Jun 2nd, 2023

[Updated] PCN # ESW490-49 – Schottky Barrier Rectifier DSTxxx TO-277B Packing Product Reel Change

1.0 Physical Difference:

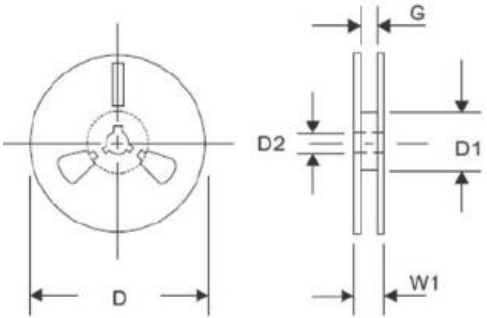
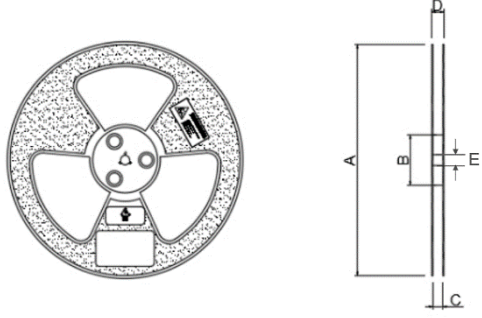
Littelfuse would like to notify you that we will replace Carboard reel with ESD plastic reel for Schottky Barrier Rectifier DSTxxx TO-277B packing Products.

Type	Current	New
Appearance		
Material	Carboard	PS
Color	White Reel	Bule Reel

Type	Current	New																									
Size (mm)	 <table border="1" data-bbox="337 598 852 693"> <tr> <td>D</td> <td>D1</td> <td>D2</td> <td>G</td> <td>W1</td> </tr> <tr> <td>±0.3</td> <td>min</td> <td>±0.2</td> <td>min</td> <td>min</td> </tr> <tr> <td>330.0</td> <td>100</td> <td>13.00</td> <td>16.00</td> <td>20.00</td> </tr> </table>	D	D1	D2	G	W1	±0.3	min	±0.2	min	min	330.0	100	13.00	16.00	20.00	 <table border="1" data-bbox="901 598 1388 693"> <tr> <td>A</td> <td>B</td> <td>C</td> <td>D</td> <td>E</td> </tr> <tr> <td>330±5</td> <td>55±5</td> <td>14±1</td> <td>18±1</td> <td>13.5±0.5</td> </tr> </table>	A	B	C	D	E	330±5	55±5	14±1	18±1	13.5±0.5
D	D1	D2	G	W1																							
±0.3	min	±0.2	min	min																							
330.0	100	13.00	16.00	20.00																							
A	B	C	D	E																							
330±5	55±5	14±1	18±1	13.5±0.5
